## **PRODUCT CHANGE NOTIFICATION**

PCN Number: 661

Date of Issue:	05/23/2023
PCN Effective Date:	05/23/2023
Last Time Buy Date:	-
Last Time Ship Date:	-
Type of Change:	Eng. dwg update for HMC & HMS series
Title of Change:	Retainer ring, sub-component change.
Description and Reason for Change:	Sub-component change. Retainer Ring: from RNG_461(round) to RTN_714 (winged).

TITLE:  
CLIPLITE HMC 461  
ASSEMBLY

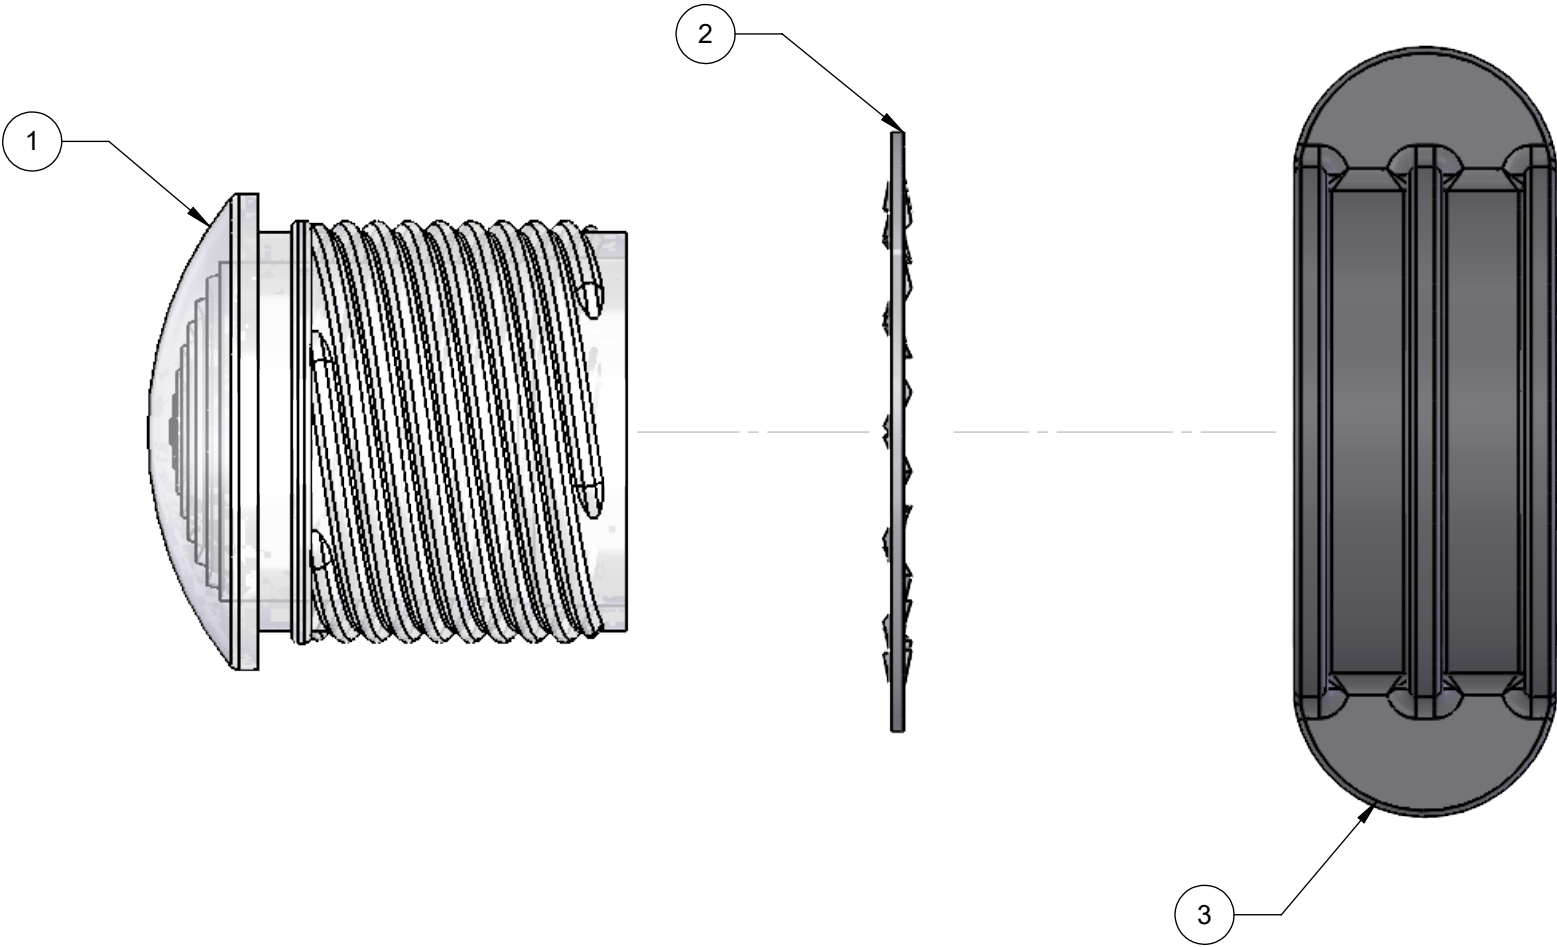
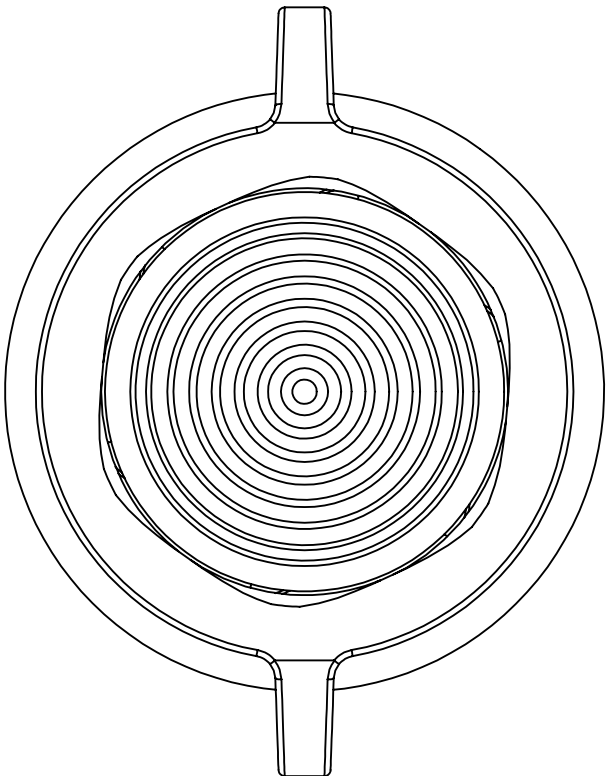
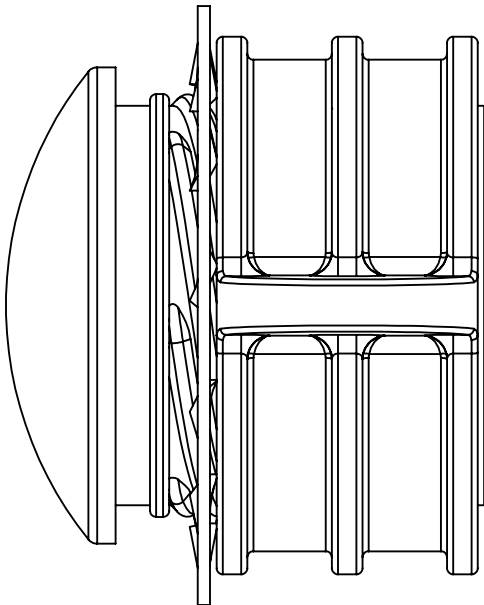
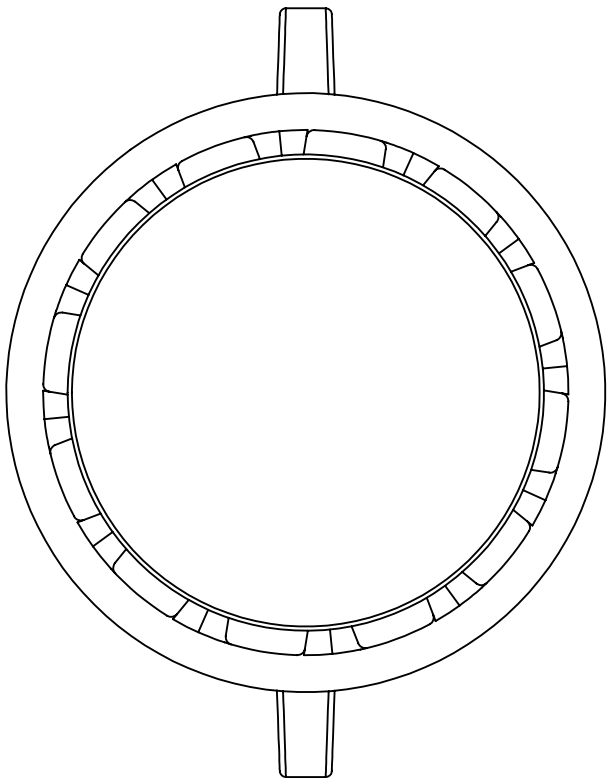
REVISIONS				
ECN#	REV.	DESCRIPTION	DATE	INITIALS
	001	REVISED PER ECR111009AZ01	7/7/10	KH
2148	002	RETAINING RING PART NUMBER UPDATED	TBD	AS

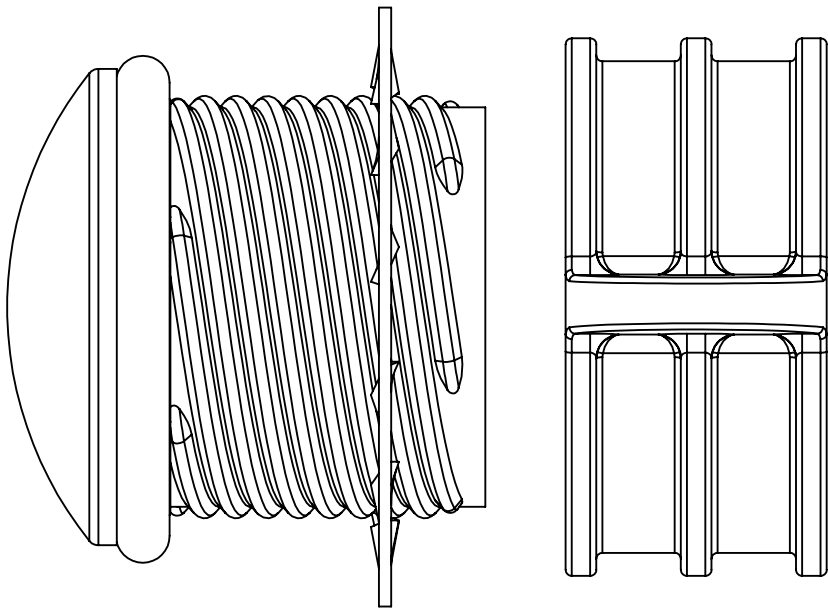
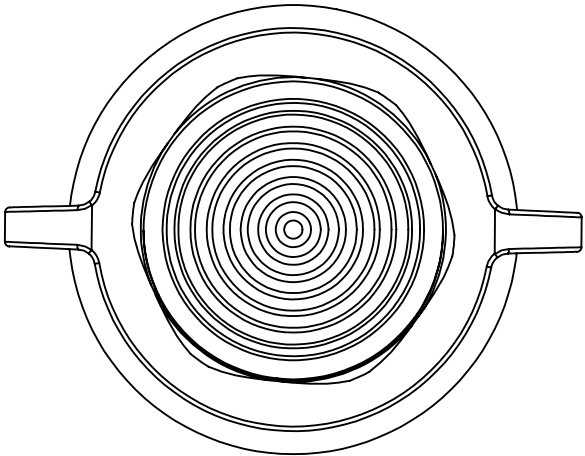
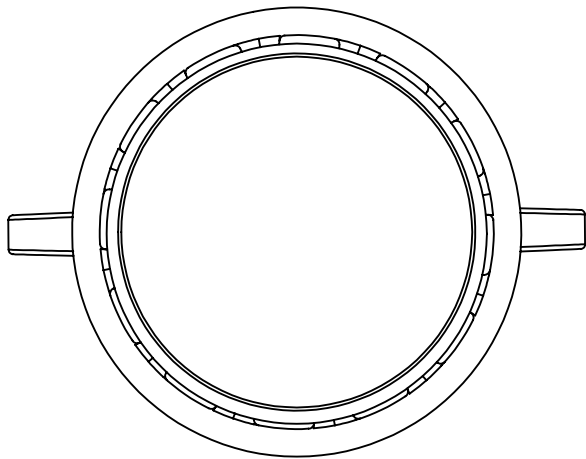
REVISIONS				
ECN#	REV.	DESCRIPTION	DATE	INITIALS
	001	REVISED PER ECR111009AZ01	7/7/10	KH
2148	002	RETAINING RING PART NUMBER UPDATED	TBD	AS
